## Technical Note

Project No: ITL16195  
Project Title: Broadwater Gardens  
Title: HCC Highways Response  
Ref: NM/MD/ITL16195-007  
Date: 19 February 2021

1.2 Hertfordshire County Council (HCC), as the local highway authority, published a response to the application dated 10 February 2021. In their response they have requested further information and details on a number of points, namely relating to the proposed site access junction. Further, initial comments were provided via WHBC that required undertaking a Stage 1 Road Safety Audit (RSA) at the site access junction. This was produced and submitted, alongside a Designer’s Response, to HCC dated 29 January 2021 (report ref: ITL16195-006).

**Image 1.2: Light Panel Van Dimensions**

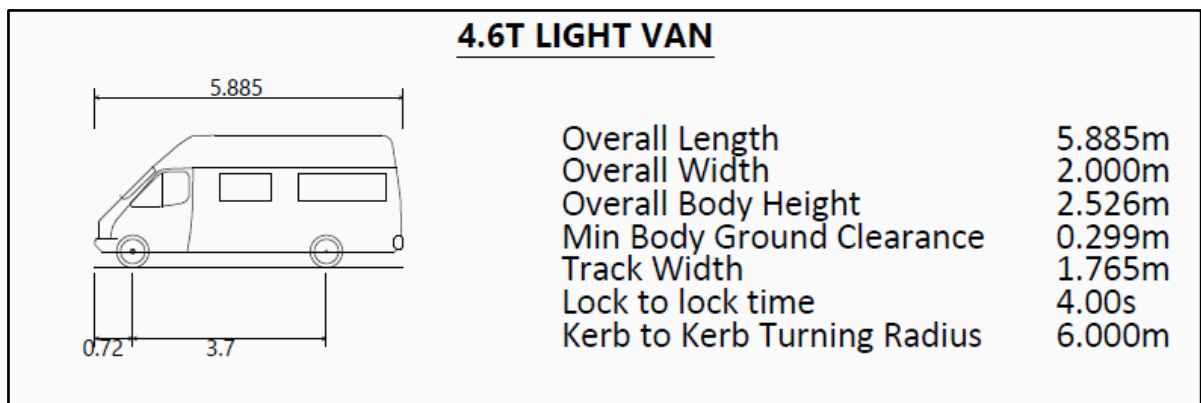
*“It is requested that additional drawings are submitted that shows a box van (typical of online grocery deliveries and servicing vehicles) on a left-turn and also a right-turn into the site whilst a car is positioned at the give-way line.”*

1.7.1 A typical online grocery delivery is delivered in a vehicle similar to the 4.6t light van. The vehicle dimensions are provided In Image 1.2.

DRAWN: JMc	CHECKED: MD	APPROVED: NM
PROJECT No: ITL16195	SCALE @ A3: 1:500	DATE: 24.11.20
DRAWING No: ITL16195-GA-005		REV: B

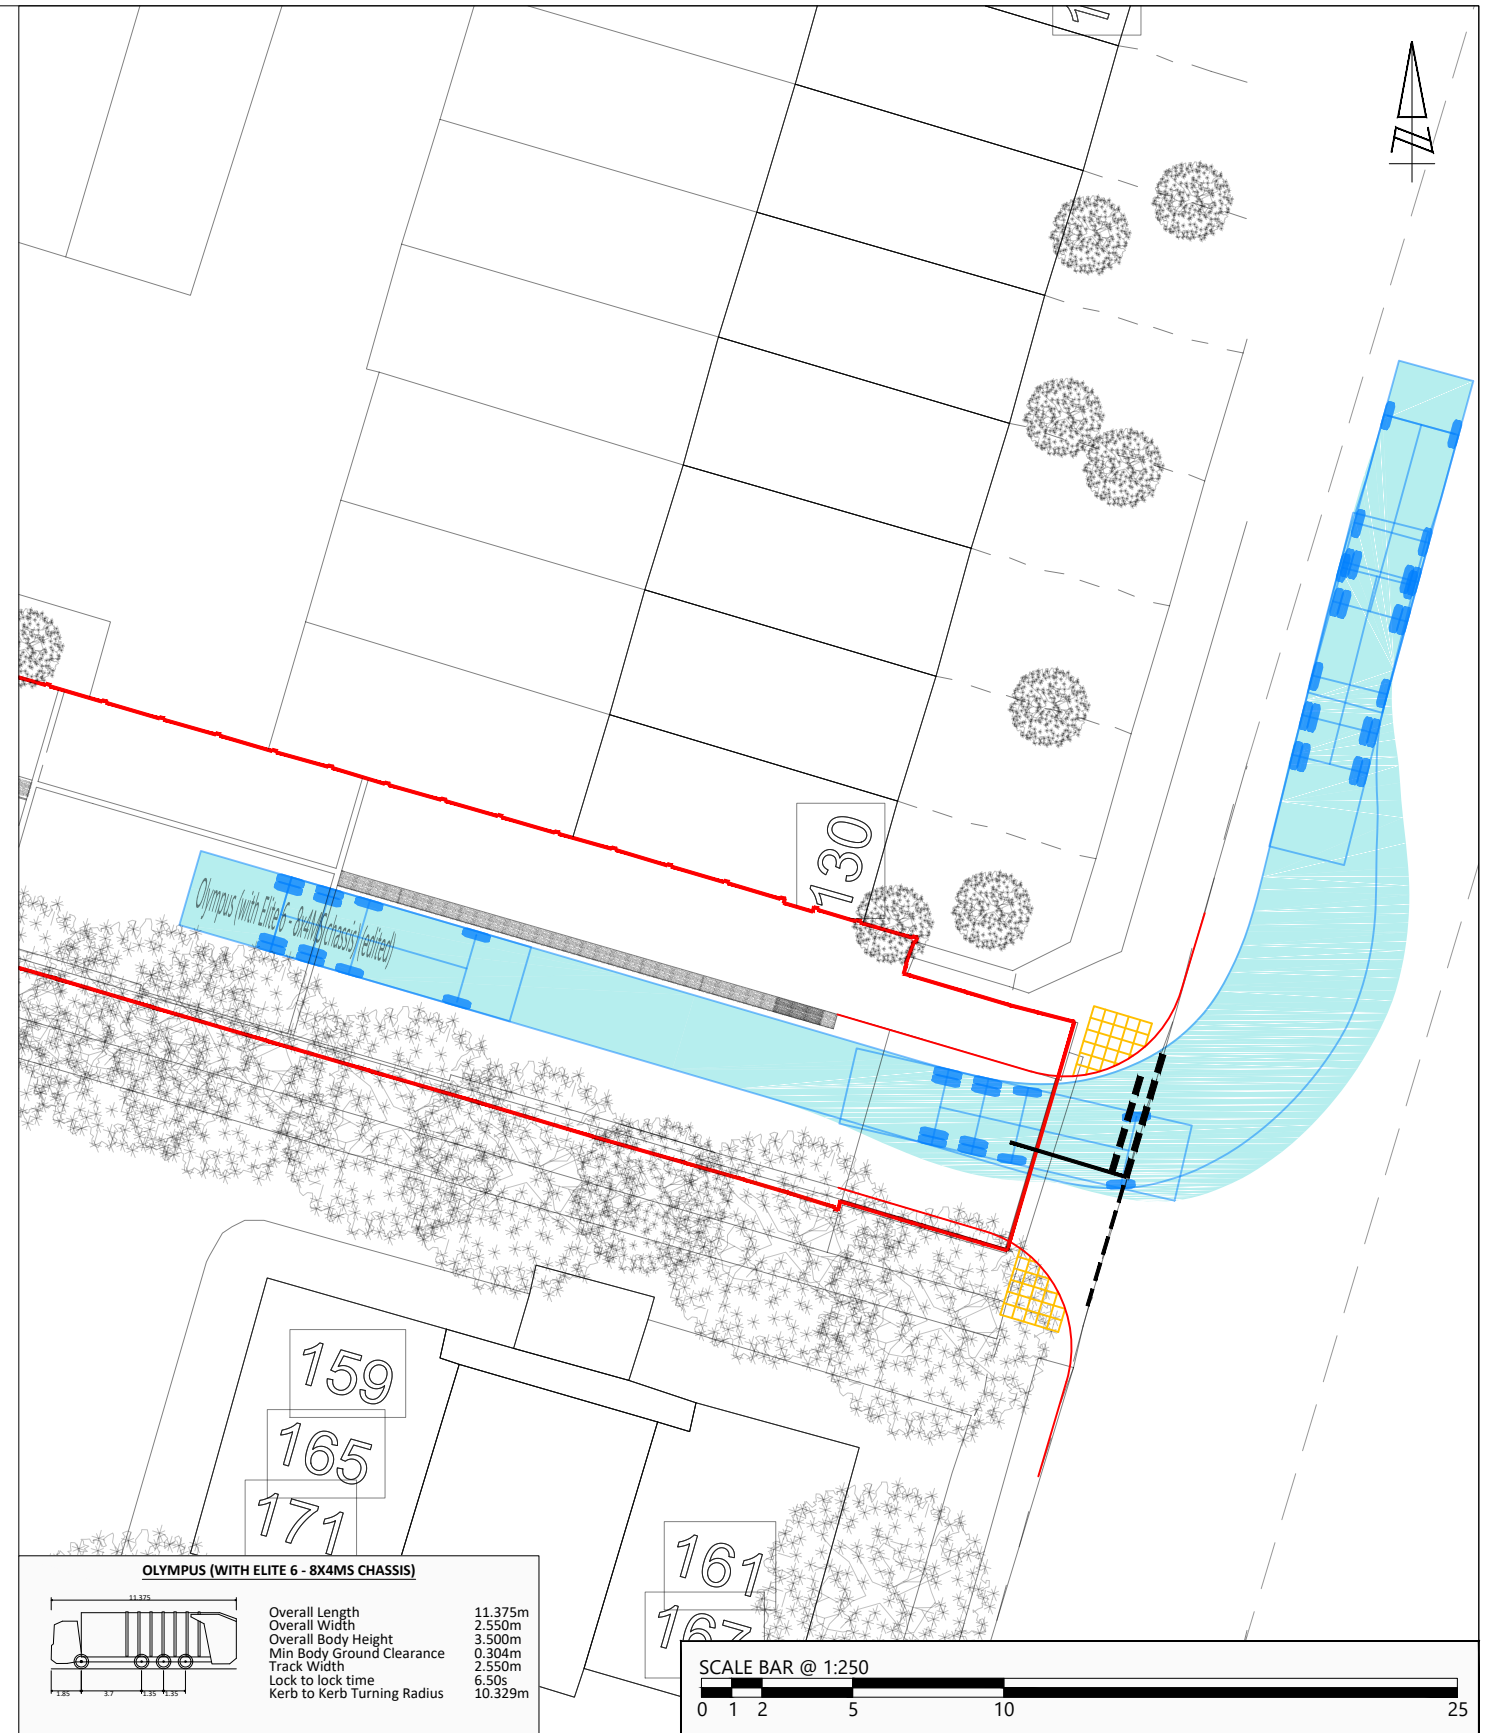
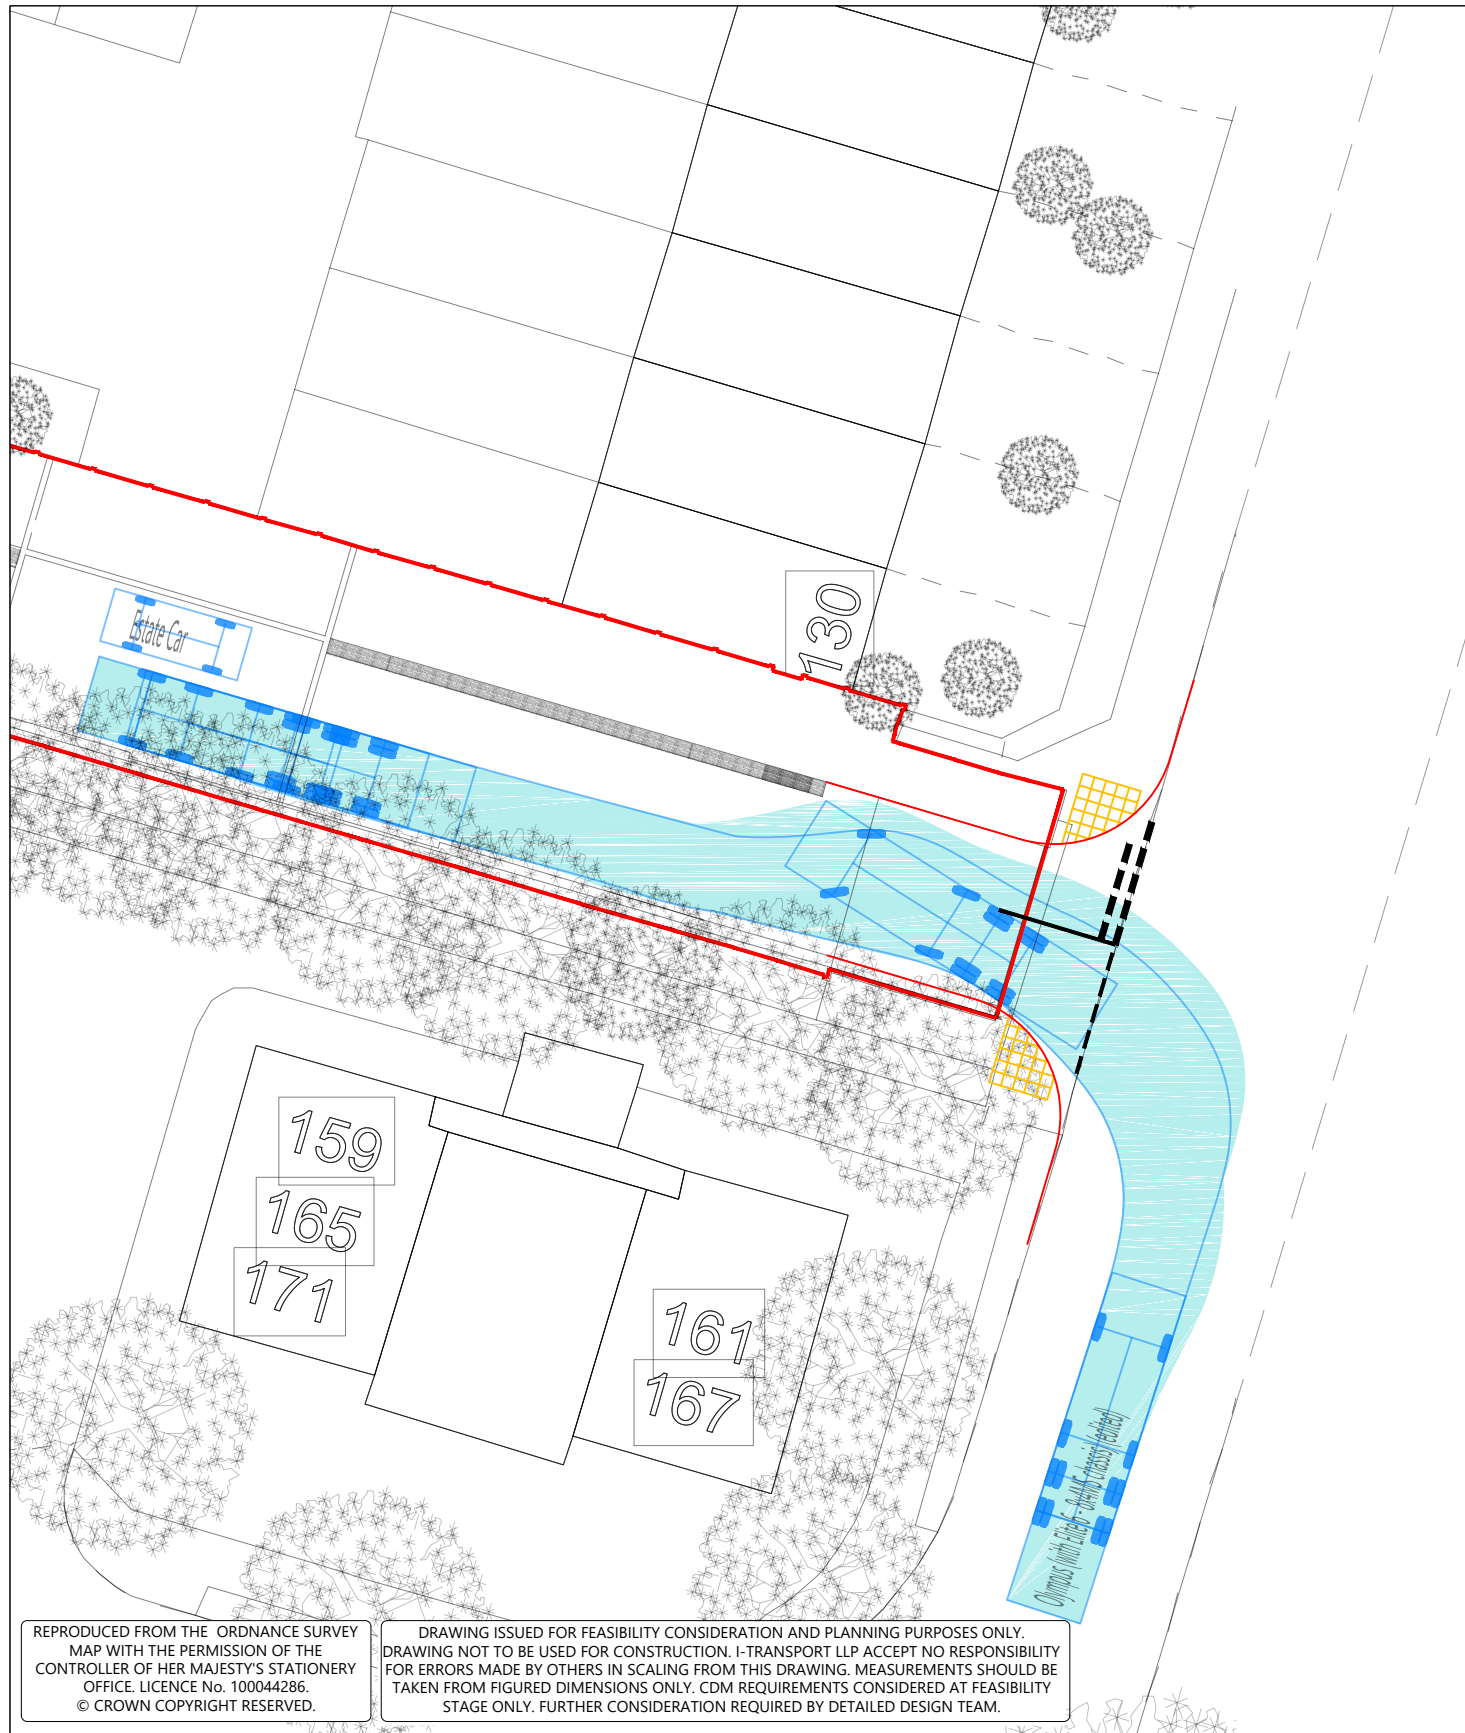
***“It can be seen that upon entering the site, the body of the vehicle has the potential to overrun onto the shared footway / cycleway. No mitigation to reduce this risk to pedestrians or cyclists has been proposed”.***

1.4.1 The swept path analysis of the large refuse vehicle demonstrates there is potential for the body of the vehicle to slightly overhang the shared footway/ cycleway along the northern side of the access road. This slight body overhang is considered to not be a highways safety issue due to the following:

1.4.2 Notwithstanding the above points, the masterplan has been amended to provide a 5.5m width carriageway in this area. The updated site access junction arrangement is illustrated in drawing ITL16195-GA-005A.

1.4.3 As a result of the above, there is a minimum width of 1.75m of available footway. This is sufficient for a wheelchair and/or pushchair to pass and oncoming pedestrian in this area, as set out in Manual for Streets (MfS) (ref: see Figure 6.8 of MfS).

DRAWN:	JMc	CHECKED:	MD	APPROVED:	NM
PROJECT No:	ITL16195	SCALE @ A3:	1:250	DATE:	26.01.21
DRAWING No:	ITL16195-GA-010			REV:	A

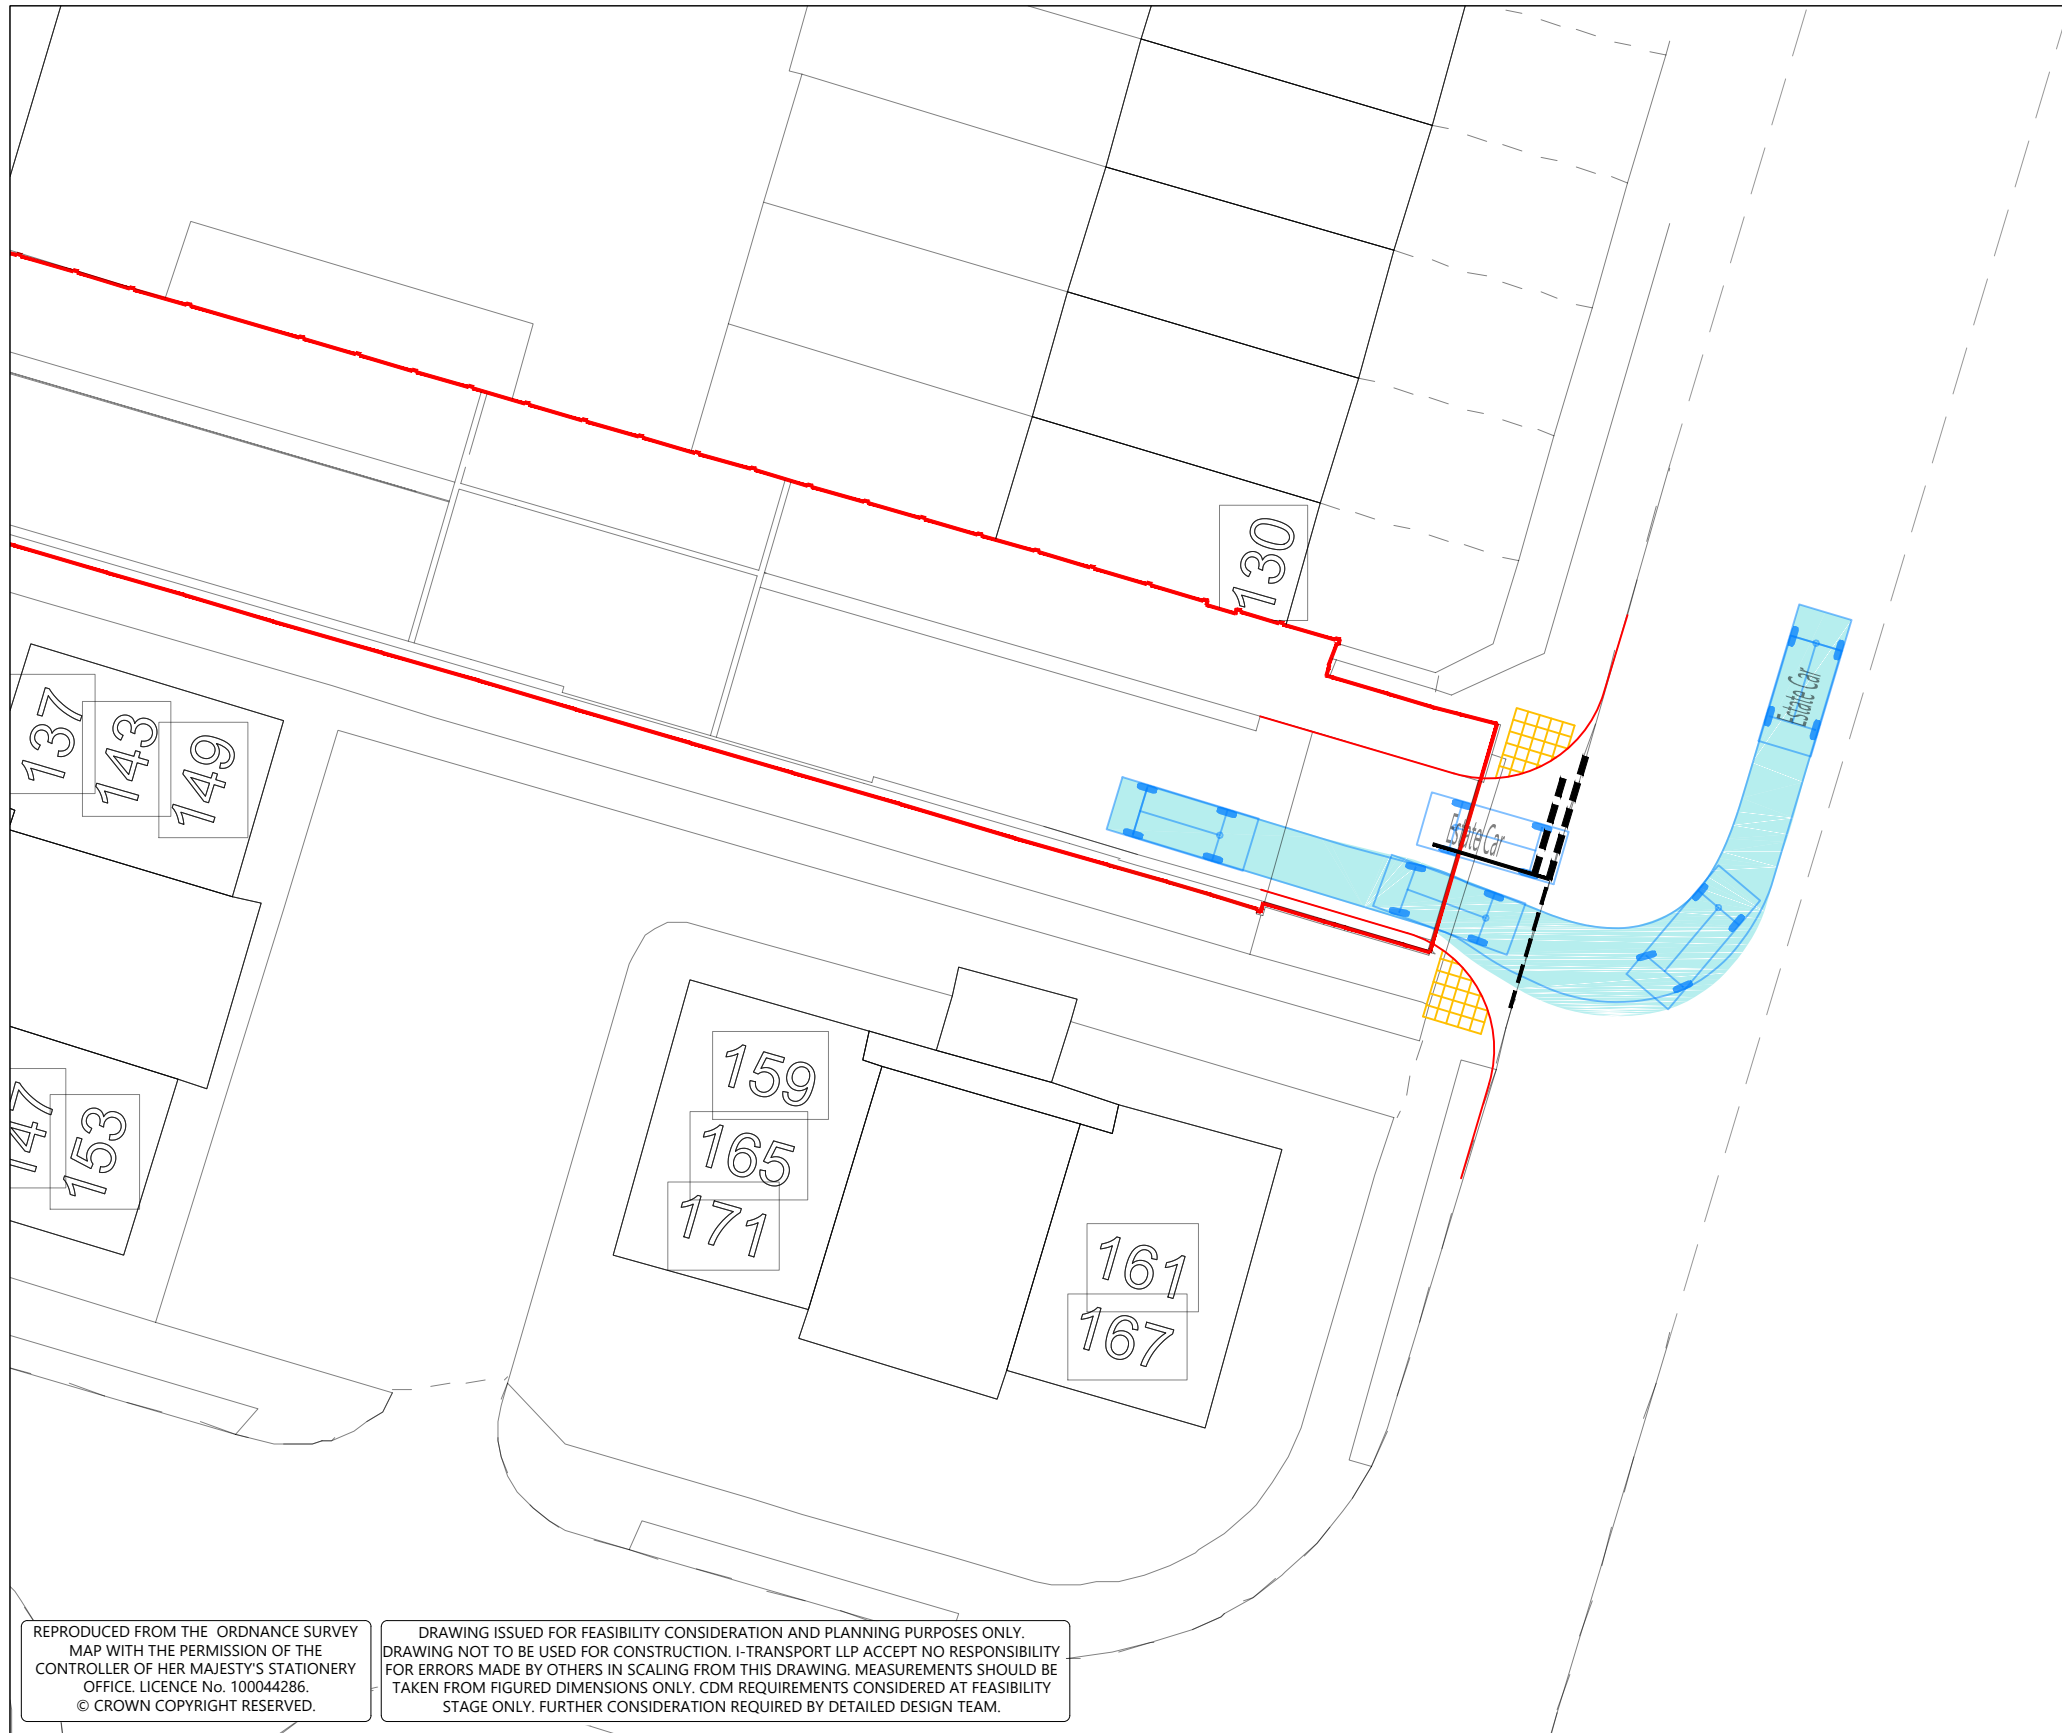
***“refuse vehicle tracking shows incursion into the opposing carriageway when starting the left turn manoeuvre [from Broadwater Road] which could cause conflict with vehicles travelling in the opposing direction leading to possible head on collisions or side swipe collisions”***

1.5.1 As set out in the Designer's Response (report ref: ITL16195-006) the easing of the radius at the site access junction to accommodate the infrequent movement of a large refuse vehicle is not required due to the following:

1.5.2 Notwithstanding these points, as set out above, the carriageway at the access has been widened and thus the updated swept path analysis of a refuse vehicle is provided in Drawing No. ITL16195-GA-010A. In addition, the swept path analysis if the most frequent vehicle movement likely to occur (a car passing another car) at the site access has also been updated and is illustrated in Drawing No. ITL16195-GA-011A.
